RE: SR 167 Puyallup to SR 509
 Tier II DEIS Review

RE: SR 167, Puyallup to SR 509 – Tier II Draft Environmental Impact Statement

RESPONSE L06-004

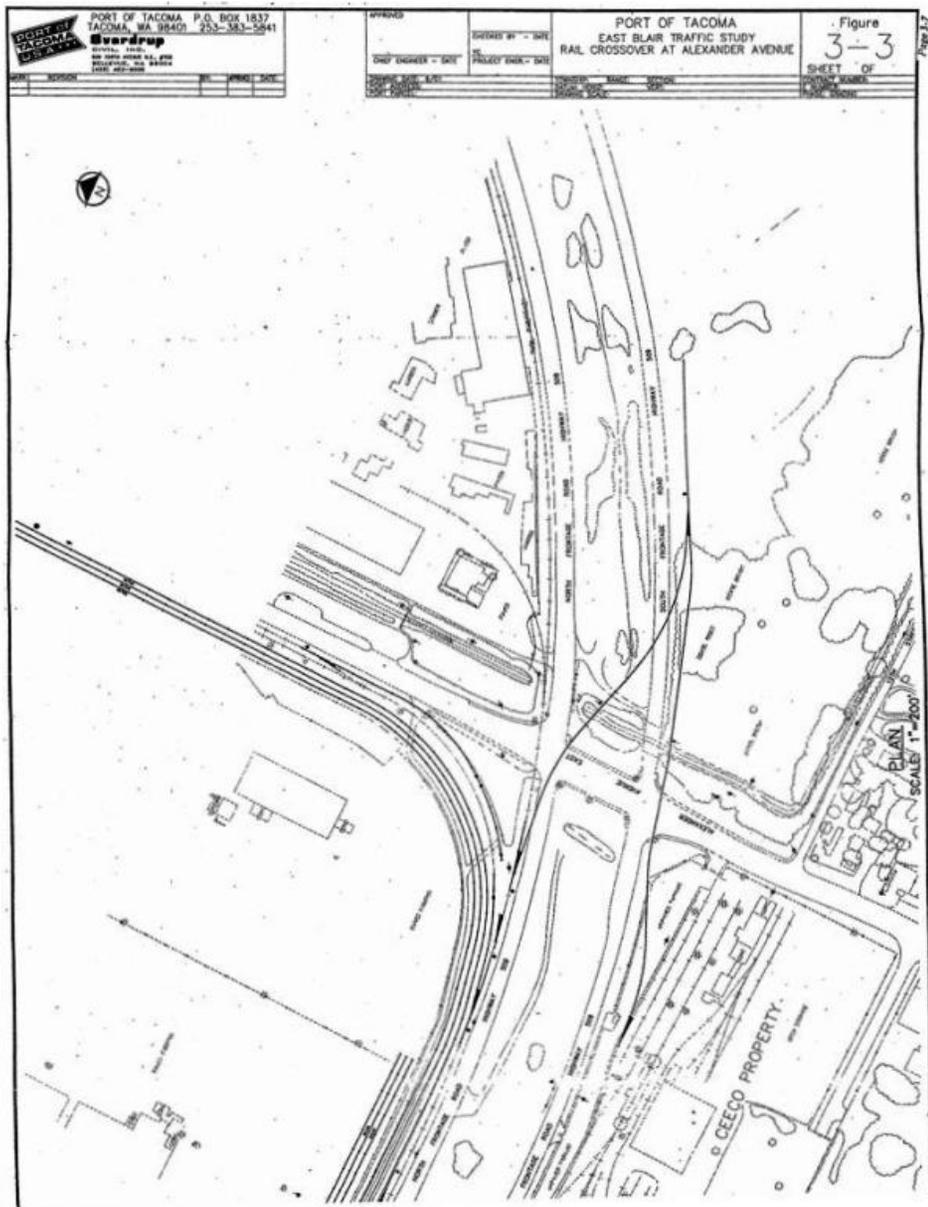
There currently exists an "at grade" rail crossing of SR 509 just west of Alexander Avenue. A grade separated rail corridor for access to the Ceeco property is not considered in this DEIS. The proposed rail trackage will cross near the proposed siting of the southbound ramp SR 509 to SR 167 and will need to cross under the elevated SR167 near Alexander Avenue. The ramp design will need to consider the rail right-of-way and the elevated SR167 roadway needs to consider the railroad required 'envelope' dimensions. As this project moves from the EIS towards design, the Port will want to remain involved in the design of the area of the SR 167 connection to SR 509 with regards to potential encroachment on rail trackage in this immediate area. We have provided a proposed rail configuration plan as part of this response for your review.

WSDOT and the Port has been working together to develop a rail crossing into the CEECO property. Please also see the "Rail Operations" section in section 3.14 of the FEIS.
